3sigma Reference Guide Addendum

This addendum adds to/modifies information presented in the *3sigma Reference Guide* (QD-19.8), dated February 2002. Versions of the manual dated later than February 2002 include the information presented in this addendum.

LCD Display Contrast Adjustment (firmware V1.07 and later)

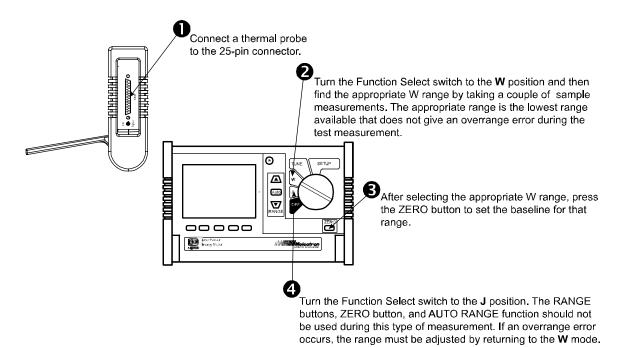
(3sigma Reference Guide—p. 9) Pressing and holding the Display Control button for more than ½ second incrementally adjusts the LCD display contrast until it reaches either the minimum or the maximum contrast intensity. At that point, contrast begins adjusting towards the other extreme.

Example: (refer to the following illustration) Assuming that minimum (lightest) contrast intensity = I and maximum (darkest) contrast intensity = I0, the sequence of contrast changes is: 1, 2, 3, 4, 5, 6, 7, 8, 9, 10, 9, 8, 7, 6, 5, 4, 3, 2, 1, 2, 3, 4, 5 . . .

Note: Whenever 3sigma powers-up and the Display Control button is initially pressed and held, contrast adjusts towards the *minimum* (lightest) contrast level. Also note that whenever 3sigma first powers-up, contrast intensity is automatically set to the *last* contrast level previously used.
